ADDENDUM NO. 6  
TO THE CONTRACT DOCUMENTS  
for the construction of  
**McCROSKEY ISLAND WWTP EXPANSION**

Date: August 11, 2022  
Project No.: C6A08007

**City of Sevierville, TN**  
**McCroskey Island Wastewater Treatment Plant**

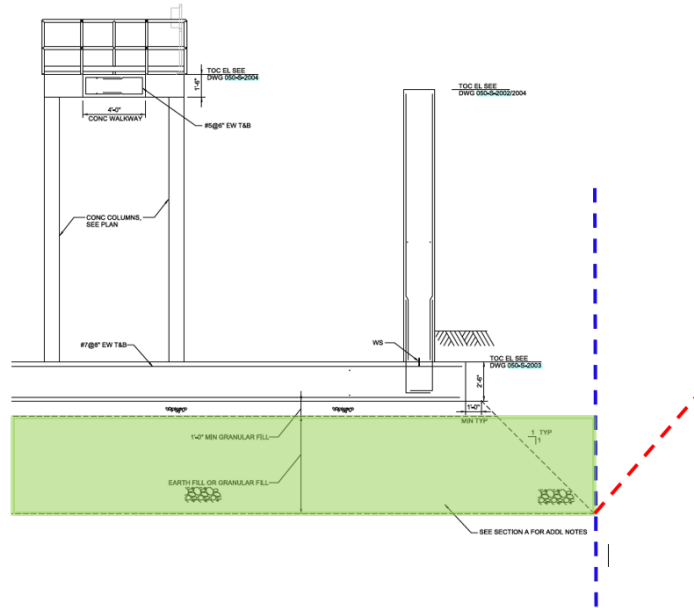
5. In Addendum No. 5, Question and Response #44 states "The overexcavation limits shown on the structural drawings, and associated notes, are not intended to define the limits of required overexcavation. See response to Question #9 in Addendum #3." To address the work to be included in the Unit-Price bid items, and the work to be included in the Base Bid, Contractors need to know: 1) where the lines will be drawn, and 2) how the work will be measured and paid. For example, Facility 050 will require excavation similar to what is depicted on the attached sketch. Per Addendum No. 5, Q and R #44, "Overexcavation starts at the bottom of the 1' minimum thickness granular fill layer." How will the necessary work (overexcavation and refill) to the right of the 1:1 slope be measured and paid? Please define these limits more accurately and confirm the methods for measurement and payment.

(Sketch provided with question)

**Response:** A vertical line from the toe of the over-excavation 1:1 slope is the limit of measurement for over-excavation. The image below shows the area for measurement of over-excavation in the shaded green box. The vertical dashed blue line is the limit of measurement; to the right of this line is where shoring would be provided, or as in the sketch provided, a sloped cut (red dashed line) would occur. The work to the right of the blue line is to be absorbed in the unit price pay item for over-excavation. This is consistent with the Payment Procedures 1.06.H table item 4 measurement description. This is typical for all locations of over-excavation. The method of measurement is field measure of the volume of over-excavation.
